<b>COA #</b> <b>2009-COA-441</b> <b>(CAMA)</b> <b>2009-VHP-020</b>	<b>INDIANAPOLIS</b> <b>HISTORIC PRESERVATION COMMISSION</b> <b>STAFF REPORT</b>		Hearing Date <b>APRIL 7, 2010</b>
	<b>935 Bellefontaine</b> <b>CHATHAM-ARCH MASSACHUSETTS AVENUE</b>		Continued from: January 6, 2010 December 2, 2009 November 2, 2009 October 7, 2009
<b>Applicant &amp; mailing address:</b>		<b>KEVIN STUCKWISCH</b> 935 Bellefontaine Indianapolis, IN 46202	Center Township Council District: 9 Jackie Nytes
<b>Owner:</b>		<b>Same</b>	
<b>COMBINED CASES</b>			
<b>IHPC COA:</b>	<b>2009-COA-441</b> <b>(CAMA)</b>	<ul style="list-style-type: none"> <li>• Construction of detached garage with partial 2nd floor with breezeway connector</li> <li>• Site work</li> <li>• Variances.</li> </ul>	
<b>BZA Variances:</b>	<b>2009-VHP-020</b>	<ul style="list-style-type: none"> <li>• Variances of Development Standards to allow Less rear yard/sideyard setback then the 10 foot minimum required.</li> <li>• Variance of Use to allow a residential use in an accessory structure in an I-3-U zoning district.</li> </ul>

**New Garage with Partial 2<sup>nd</sup> Floor**

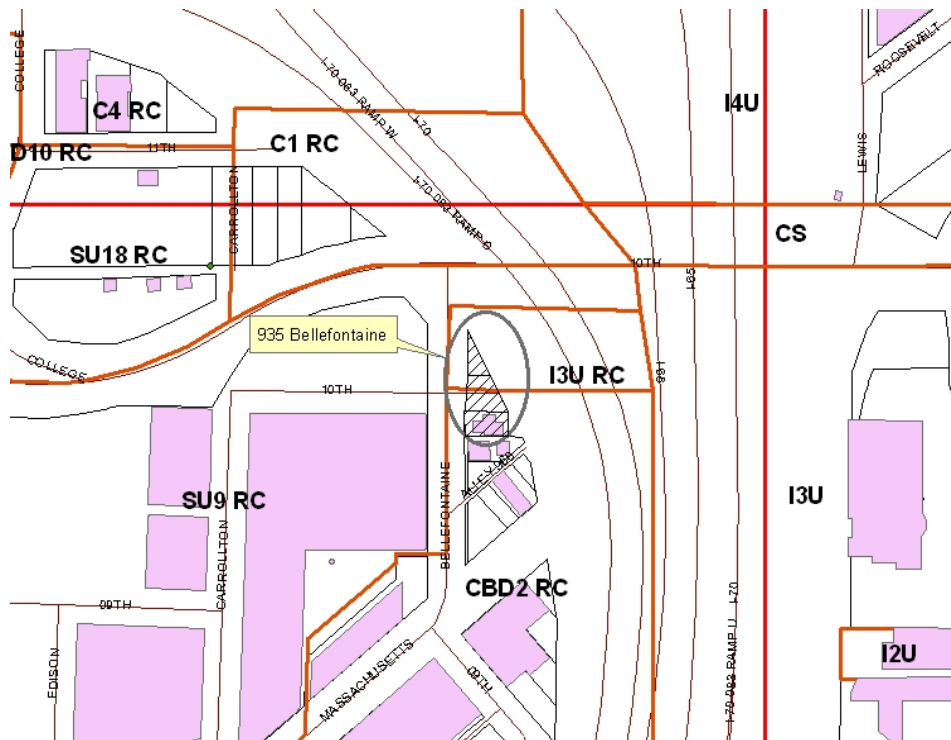
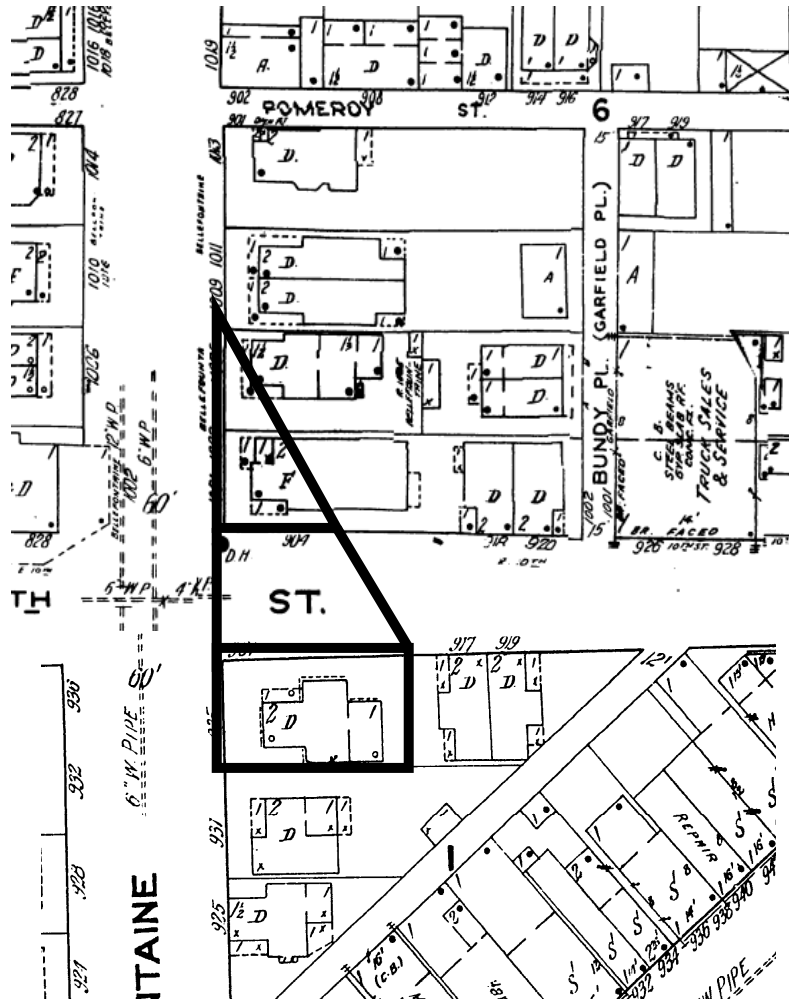
The pie-shaped lot is surrounded by rights-of-way on two sides. The lot is comprised of several segments of lots that existed prior to the Interstate construction. The applicant can only site the garage on this part of the property since the house does not have a rear yard large enough to accommodate a garage nor is there adequate access to the rear of his house.

The applicant's driveway is to be modified slightly to accommodate the garage. The driveway shape will change slightly to accommodate a concrete parking area next to the proposed garage. This is to allow for the garage to be built closer to the house and for the garage to fit on the site well and is consistent with the construction of the Cultural Trail. The applicant has shown the layout for the Trail on the site plan.

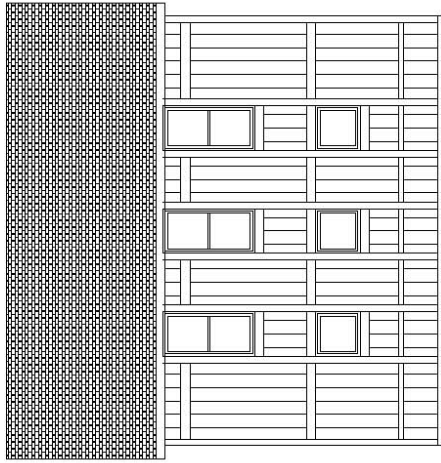
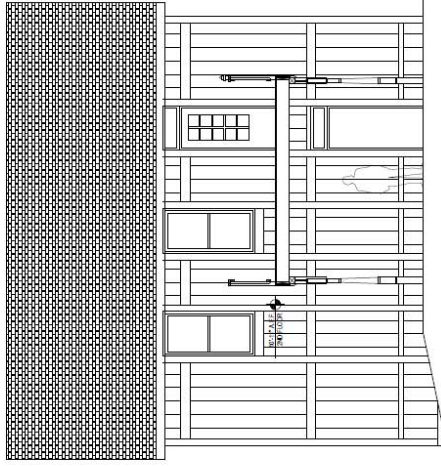
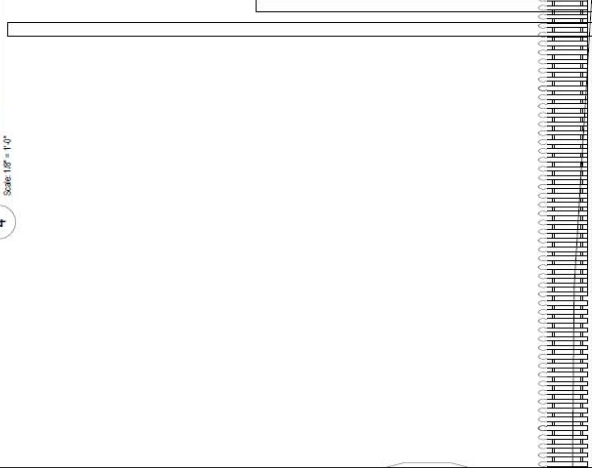
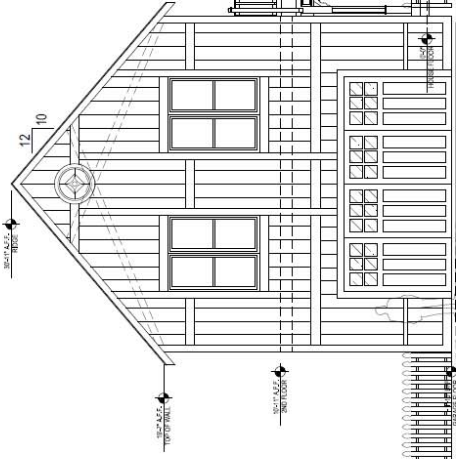
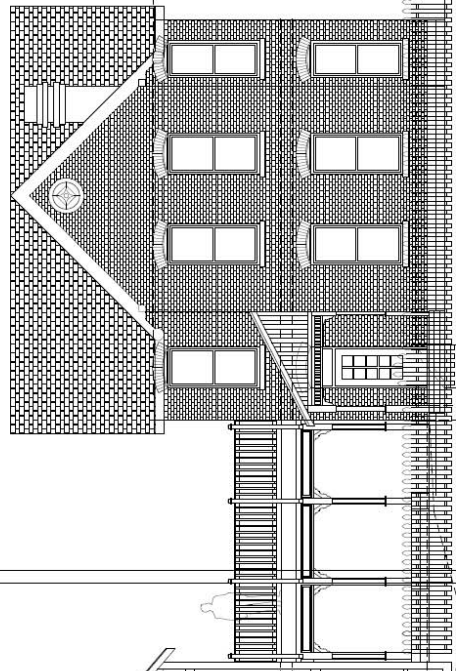
The proposed structure is to contain a two-car garage with a partial second floor for a workshop area. The new garage is going to be facing the street. Therefore, staff worked with the applicant to come up with a design that is compatible with the house but also appropriate in scale sitting next to the house instead of behind it. The front facing gable helps to achieve compatibility with the house. Vertical board and batten siding is proposed instead of brick, since matching the brick on the house would be difficult. The vertical siding also helps the structure appear more as an accessory structure. Staff believes the applicant designed the structure appropriately, especially given the tight constraints of the property and its unusual location.

There will be a connector to the house that is open in design. This connector provides covering for the homeowner while also showing that the two structures are related. Both structures appear as separate structures while being compatible with each other and the surrounding area. This is the last structure on the block, but there is a very similarly designed Victorian house to the south and this new design relates well to it.

- 4) **Siding and trim materials must be solid wood and must have a smooth texture, free of major imperfections. No rough-sawn finishes are permitted. Siding exposure and pattern shall match the historic house.**
